Harts Farm Way, Havant

Stage 1 Road Safety Audit

June 2021

Drawing No. 205465/PD06-Rev A – Potential Secondary Access

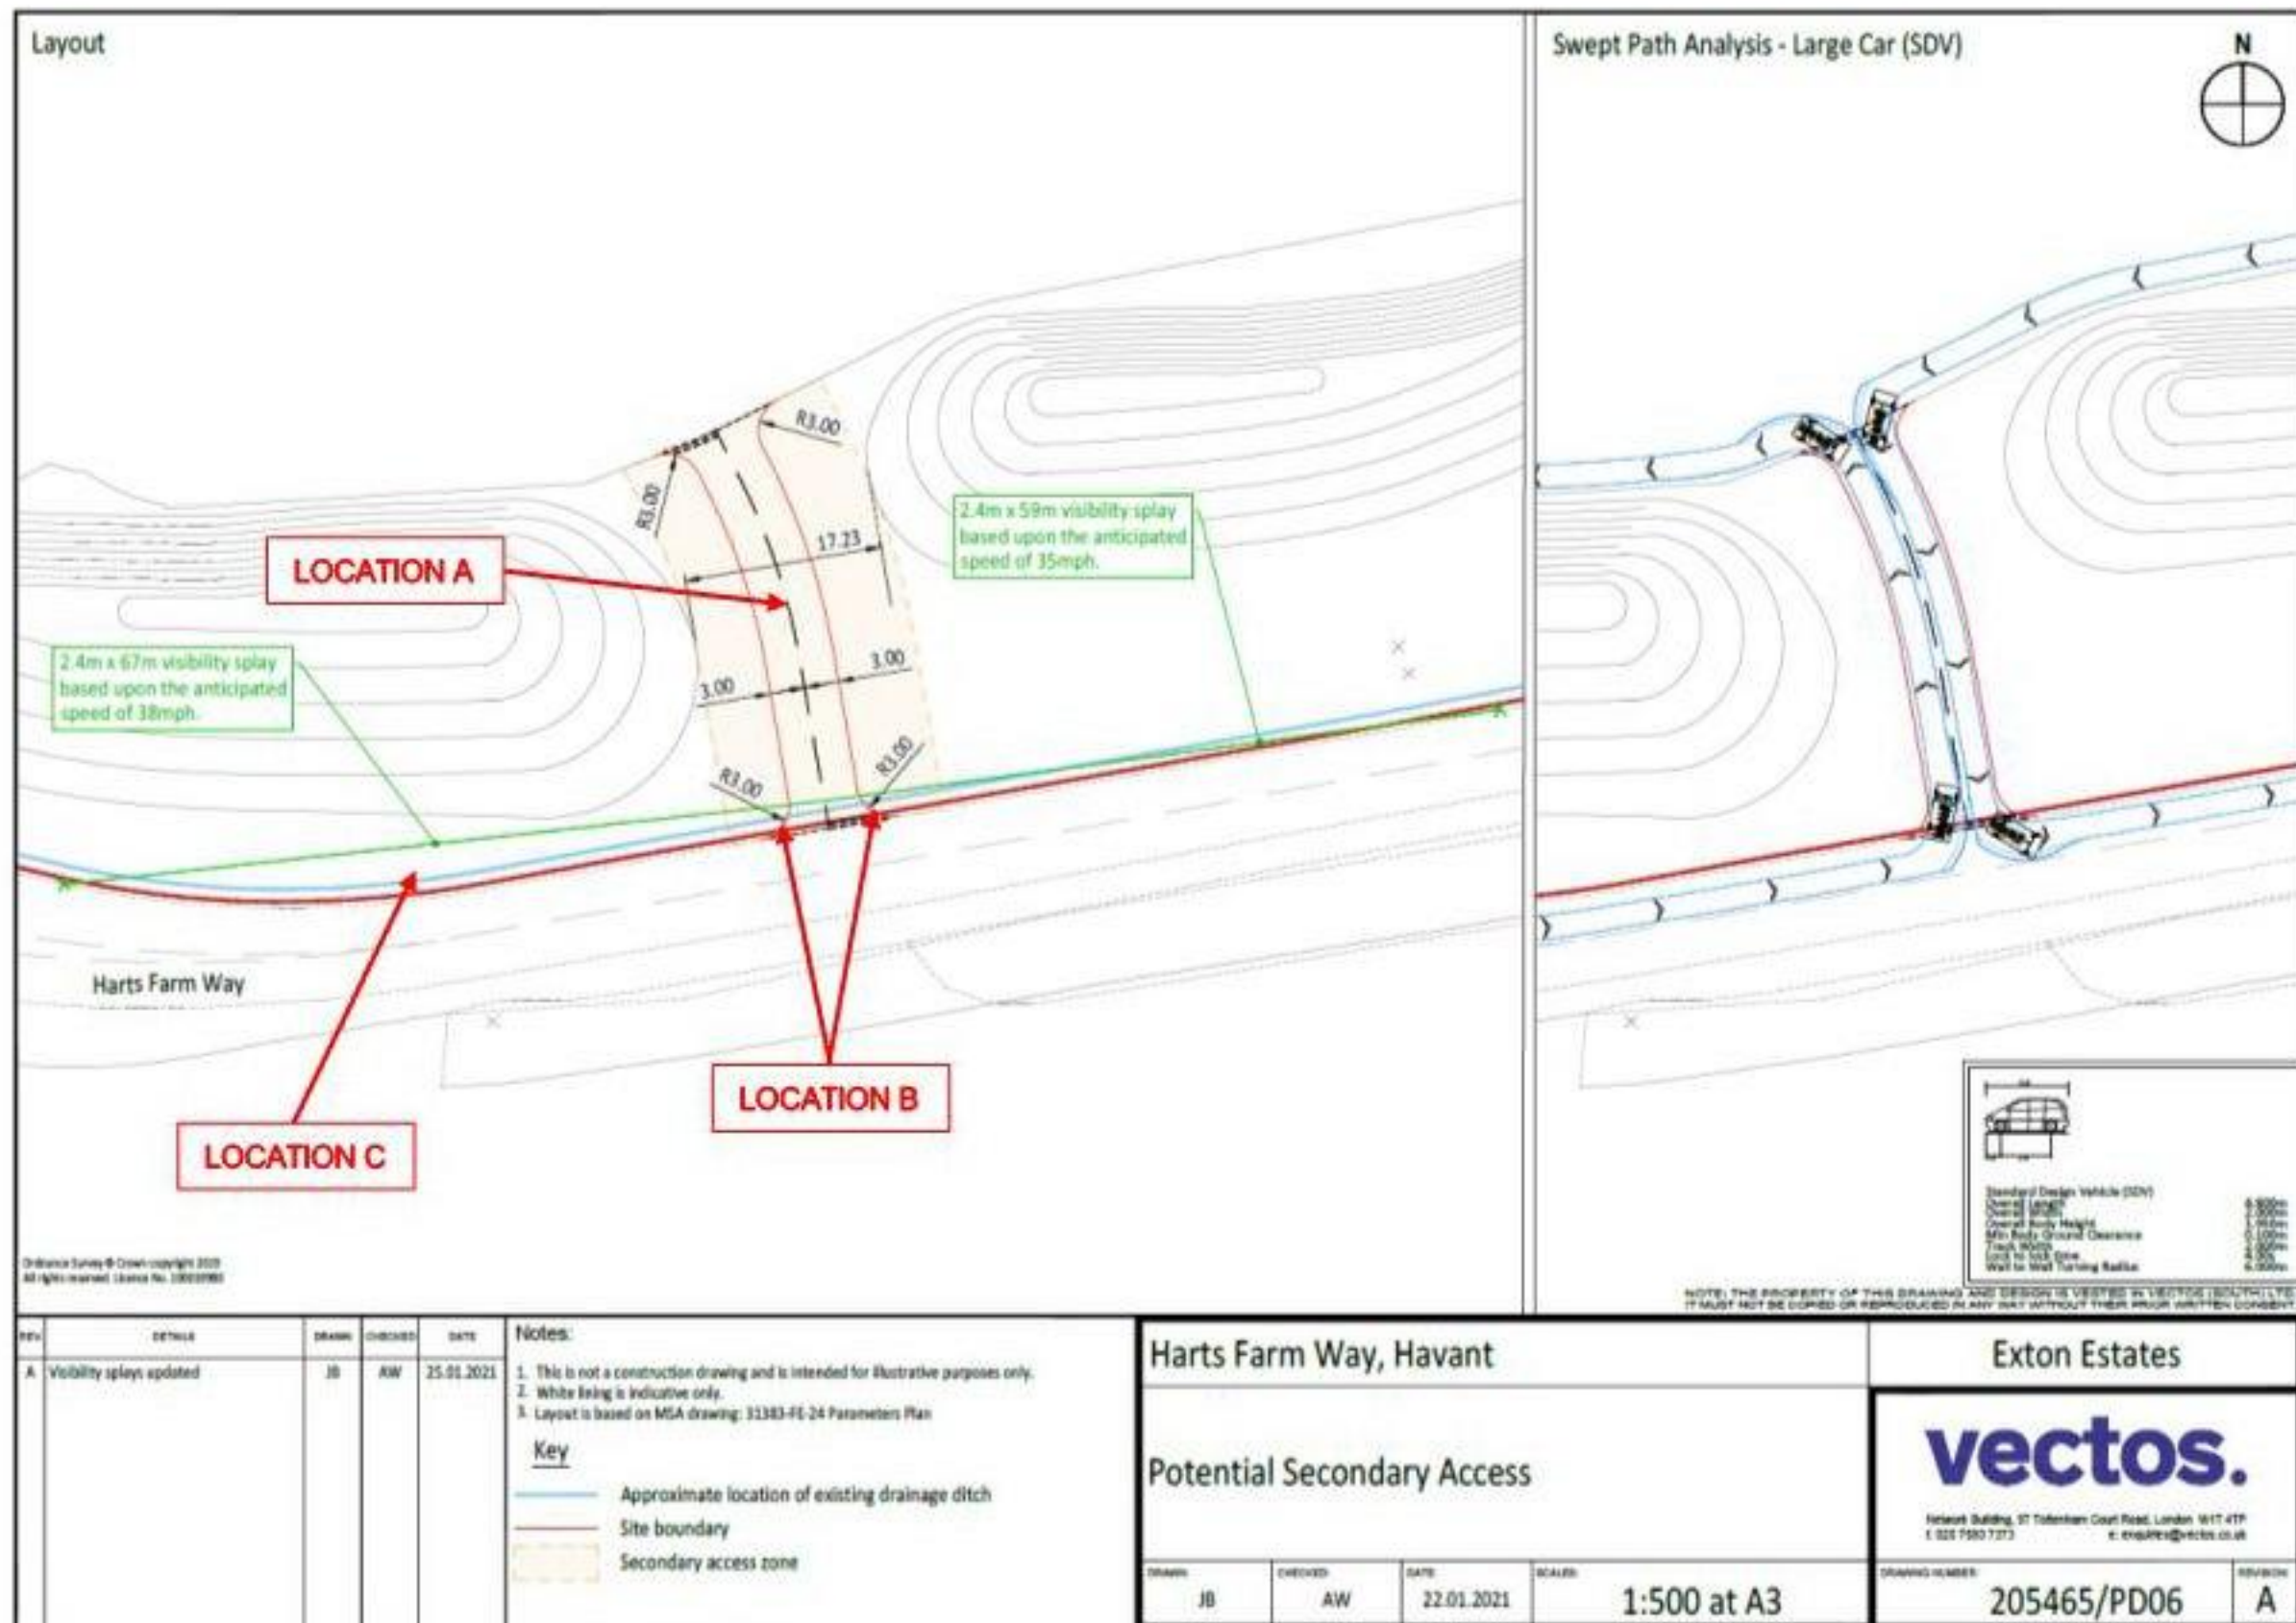
Location A: Proposed secondary access - private vehicles.

Summary: Short length of the access link may lead to queuing of vehicles causing shunt type collisions on Harts Farm Way.

Designs show a short access road leading into the site from Harts Farm Way with priority-controlled road markings at each end of the link. This short length of carriageway may lead to vehicles accessing the site, queuing back onto Harts Farm Way during peak access / egress times. The arrangement may potentially cause shunt type collisions for following vehicles.

Location B: Proposed secondary access priority controlled 'T' junction.

Summary: Small radius of the junction may lead to slow access movements and potentially cause shunt type collisions on Harts Farm Way.

Designs show that the proposed secondary access junction is to be created with 3m radii geometry at the junction bell mouth. These reduced radii may lead to excessive braking and slow access movements for vehicles entering the site. This arrangement may in turn lead to shunt type collisions at the site access

Location C: Proposed secondary access priority controlled 'T' junction, visibility splay.

Summary: Existing vegetation within the proposed splay will obstruct visibility and may lead to side swipe type collisions between vehicles.

Designs show a visibility splay to the west of the secondary access point. This splay is shown to cut beyond the edge of carriageway. At present this area is filled with high growing vegetation that will obstruct visibility from the proposed junction. This arrangement may lead to injudicious egress movements and in turn cause side swipe type collisions on Harts Farm Way.

It is recommended that the priority of the internal access junction be amended to allow for unopposed movements into the development site.

It is recommended that the bell mouth radii at the secondary site access junction are increased.

It is recommended that the existing vegetation is to be removed to ensure the clear provision of the appropriate visibility splays.

Drawing No. 205465/PD07-Rev A – Proposed Crossing with Central Refuge Island

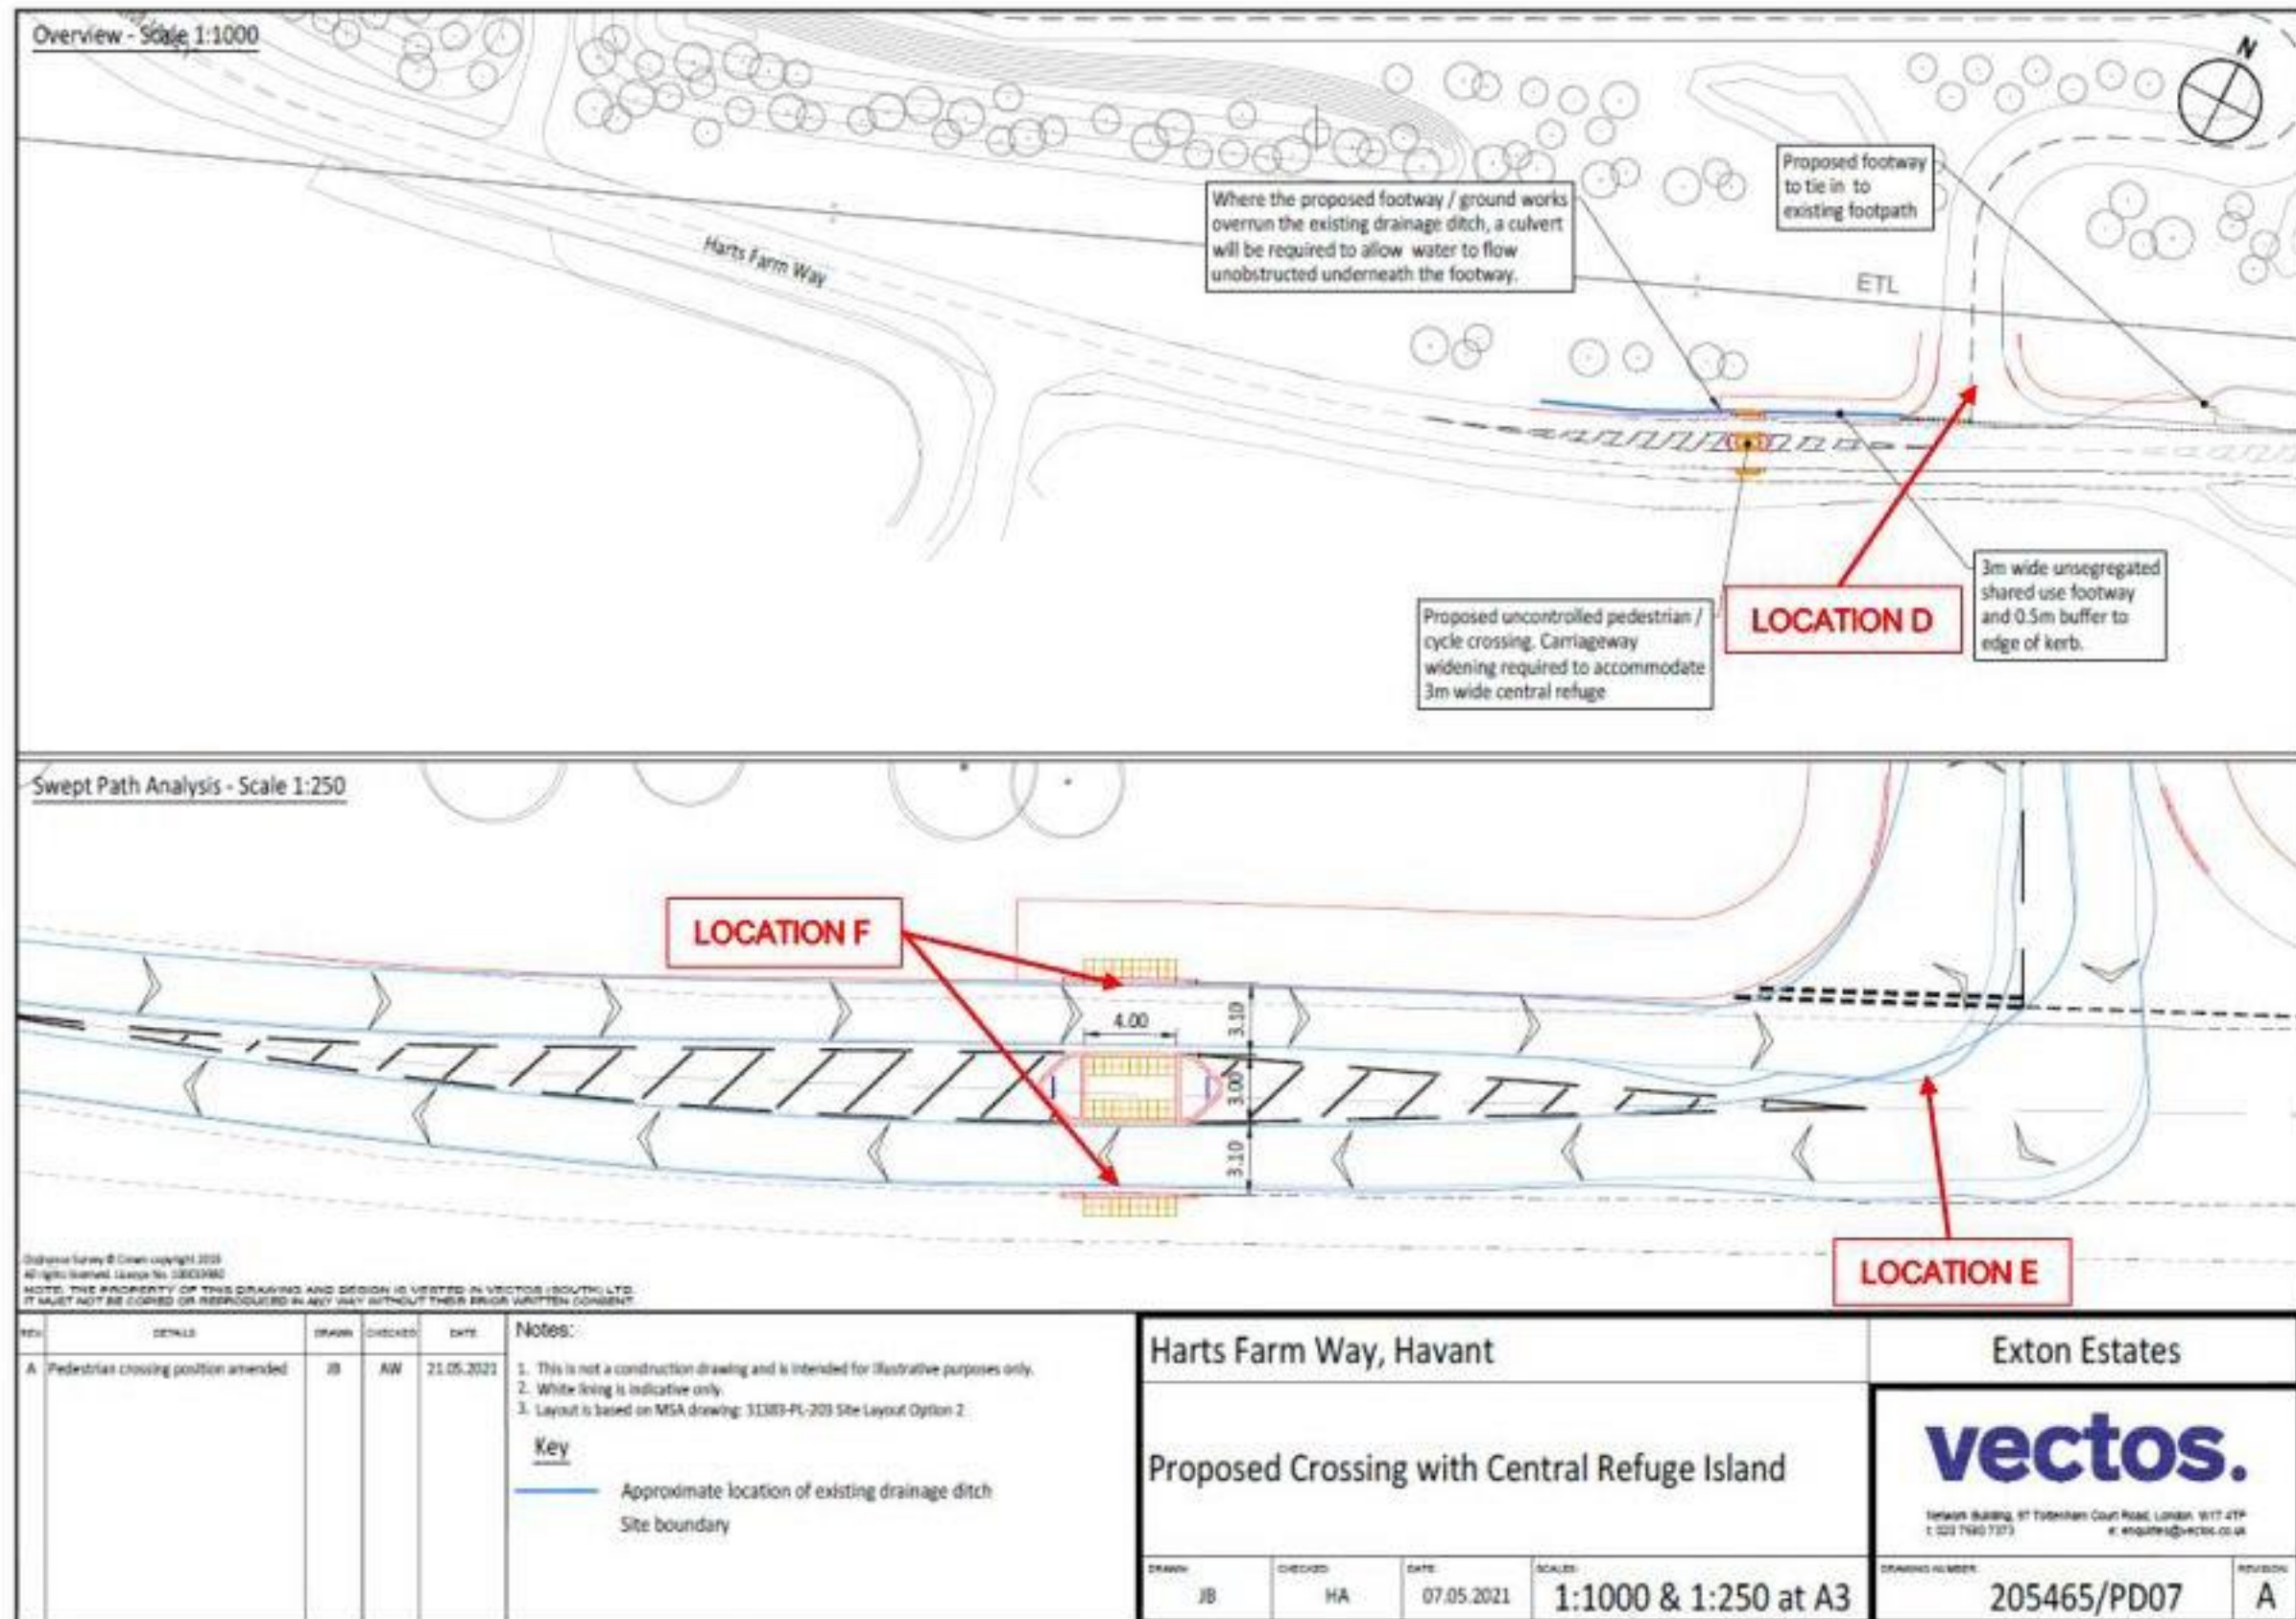
Location D: Primary site access junction, non-motorised user provision.

Summary: No facility for pedestrians to cross from the eastern side of the site access and enter the shared use facility may lead to collisions between vehicles and pedestrians attempting to cross the access road.

Designs show a proposed shared use facility to the west of the proposed primary access junction and also a footway facility on the eastern side. There are no proposals shown to allow pedestrians to cross to the shared use route and continue their onward journeys utilising the new shared use crossing facility. This arrangement may lead to pedestrian crossing where it is unsafe to do so and may potentially lead to collisions between vehicles and pedestrians on site access road.

Location E: Primary site access junction, swept path analysis.

Summary: Conflict between HGV vehicles movements at the site access may lead to head on type collisions between large vehicles.

Designs show swept path analysis for large articulated vehicles entering and exiting the primary site access junction simultaneously. These swept paths cross one another on Harts Farm Way indicating that the junction cannot accommodate the two-way movement of large vehicles. This arrangement will lead to head on / side swipe type collisions between vehicles at the primary site access junction.

Location F: Proposed shared use crossing facility.

Summary: Swept path analysis of HGV's are in close proximity to the edge of carriageway and shared use crossing which may lead to collisions between large vehicles and non-motorised users waiting at the crossing.

Designs show a proposed shared use crossing from the primary site access junction leading non-motorised users to the existing shared use facility on the southern side of Harts Farm Way. Swept path analysis of large articulated vehicles does not show the vehicle wing mirrors. It is likely that the wing mirrors of large vehicles will over sail the edge of carriageway in this location potentially leading to collisions between these vehicles and non-motorised users utilising the new crossing point.

It is recommended that the appropriate crossing facilities are provided for non-motorised users wishing to cross from the pedestrian footway to the east of the access to the shared use route to the west.

It is recommended that amendments are made to ensure the safe two-way operation of large vehicles.

It is recommended that vehicle wing mirrors are shown on swept path analysis plans and that the appropriate clearance is provided between large articulated vehicles and the shared use crossing facility.
